**Jean Fraser - Fwd: Planning Board Meeting on 133 York St is scheduled for TONIGHT at 5:30 PM**

The Planning Board Meeting on 133 York St is scheduled for **TONIGHT at 5:30 PM in room 209 at City Hall**. Below is a summary of the two recent meetings along with concerns raised by abutters. If you share any of these concerns, please try to attend tonight's meeting.

**From:** "McGee, Martin" <Martin.McGee@FMR.COM>  
**To:** "'JF@portlandmaine.gov'" <JF@portlandmaine.gov>  
**CC:** "'mcgeekm@verizon.net'" <mcgeekm@verizon.net>  
**Date:** 10/11/2013 10:53 AM  
**Subject:** Concerns and Questions regarding 133 York Street

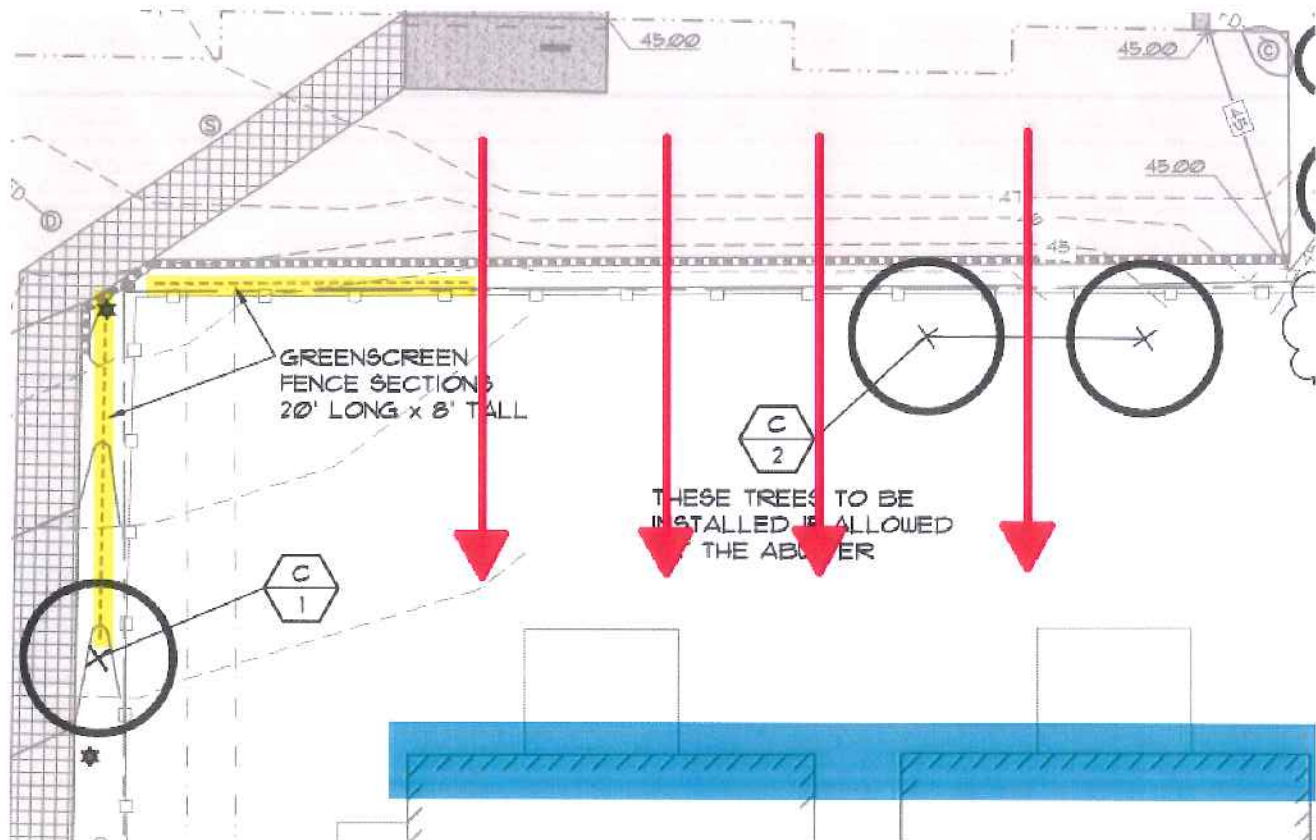
Below is an updated image with the green wall highlighted in yellow. The areas noted in blue (below) are our primary concern; hence the placement of the green wall is puzzling to me. Perhaps our concerns were not clearly stated.

AS the plan sits, the headlights from cars that are backed into your parking area will shine directly into the first floor condos (in blue) at the Flats. This unscreened area is noted with the red arrows above. The green wall and trees (as they are currently proposed) will not adequately address our concerns.

I see your concerns about the headlights as illustrated by the red arrows. I have asked the engineer to update the site plan to show a "green wall" to continue all the way across the fence. I will keep you updated on the façade.

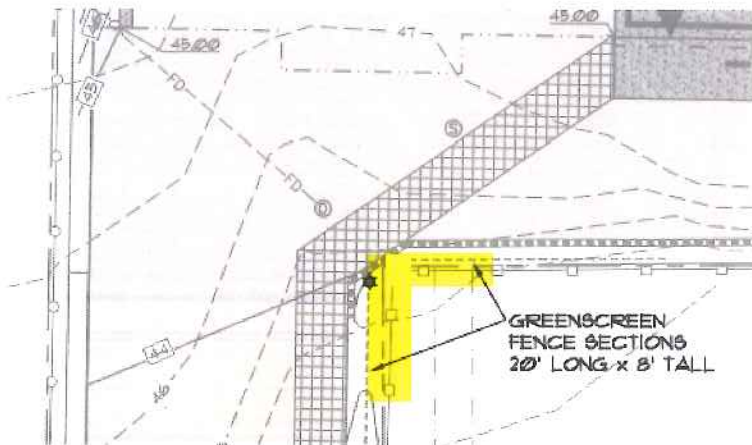
- 1) In your present design, is the green wall only planned for the section that is highlighted in yellow in the image below (the corner area)?
- 2) If YES, what provisions (beyond the trees you cited) have you made for affording the Flats screening and privacy from the parking area?

3) And finally, do you have any plans for providing privacy or screening to the adjacent Townhomes building?

1) The green wall goes beyond what you have highlighted, it is represented by the dashed line. It goes to about where the front door is located and further down the driveway.

2) The additional provision is in fact the two trees on the plan – this was suggested by the city arborist. We have added the trees and green wall to help with the privacy concerns.

3) The extra privacy for the town homes is provided with the additional 12 trees and shrubs as detailed on the plan.

McCormick Place parking spaces are 42" from the edge of the existing building on 133 York

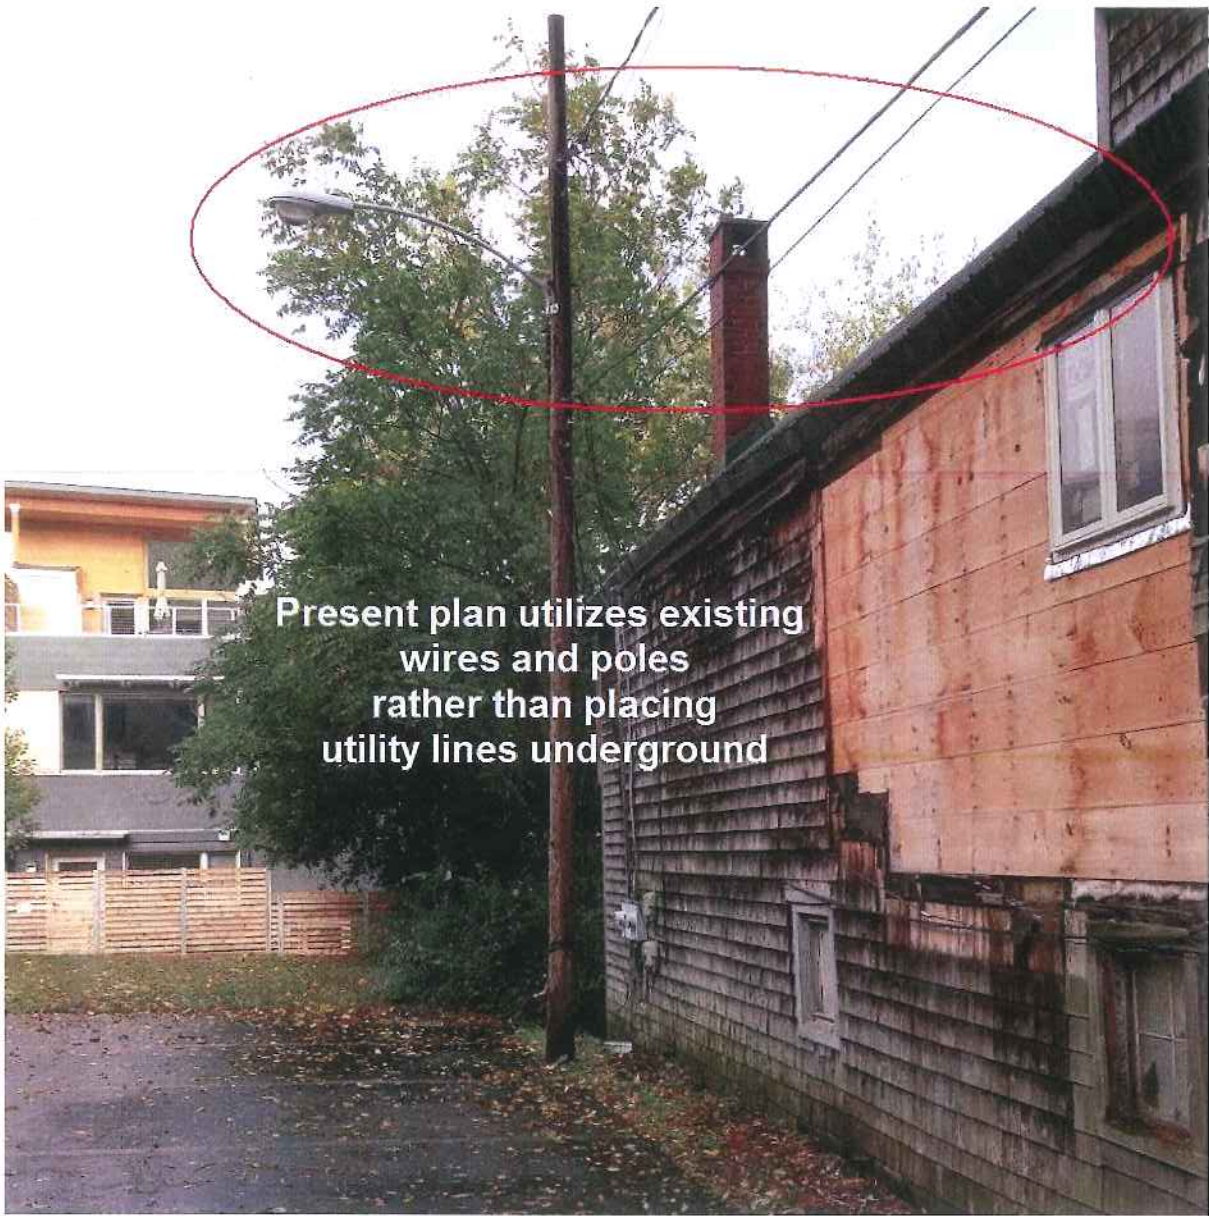
This related to our parking spaces, where due to safety reasons, I believe we will not be able to use the 5 spots abutting the construction site. Currently there is less than 4 ft from our parking lot to their property. See image 1.

**Present plan utilizes existing  
wires and poles  
rather than placing  
utility lines underground**

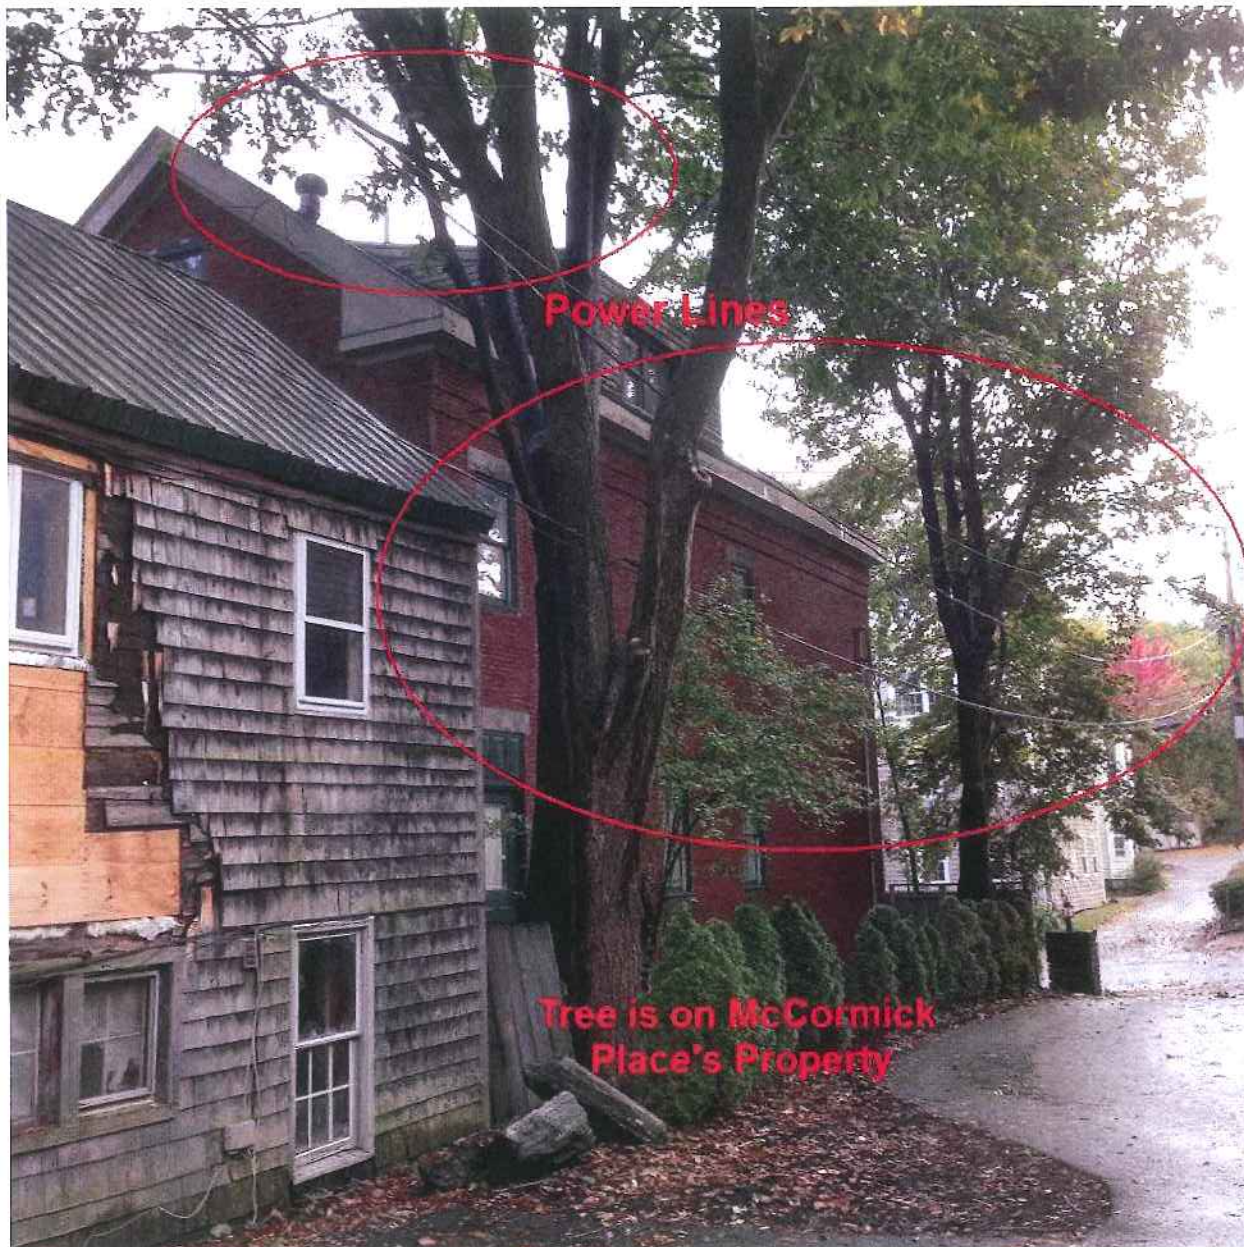
8. We are concerned about the electrical lines that run to this property. Is there any plan to update the electrical lines or bury them?

Currently they run from the opposite side of Park St through multiple trees to a telephone pole. From the pole they precariously run to the building. 3. Availability and adequate Capacity of public utilities. b. Electrical services shall be underground unless otherwise specified for industrial uses, or if it is determined to be unfeasible due to extreme cost.
